## Technical Bulletin # 1021

**Transmission:** *JA5A-EL, JF506E (Jatco 5 spd)*

**Subject:** *2-3 flare, slips in 3rd, 4th & 5th or reverse, No 3rd, 4th, 5th or reverse*

**Issue Date:** *July, 2006*

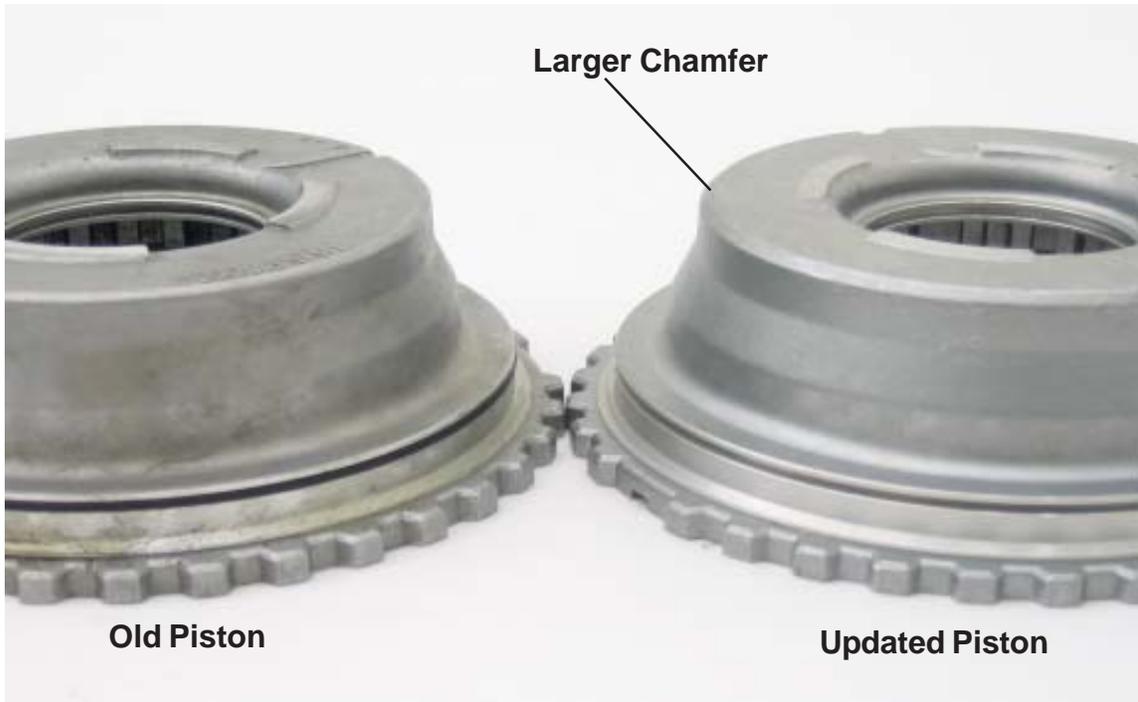
One or more of the above symptoms can be caused by a cracked Reverse piston. The piston has been updated to strengthen the piston in the area where it cracks. Mazda part # FP03-19-480.

The updated Reverse Piston is thicker and can be identified by a larger chamfer.

Because the updated Reverse Piston is thicker, the High Clutch piston has also been updated and comes with the updated Reverse Piston.
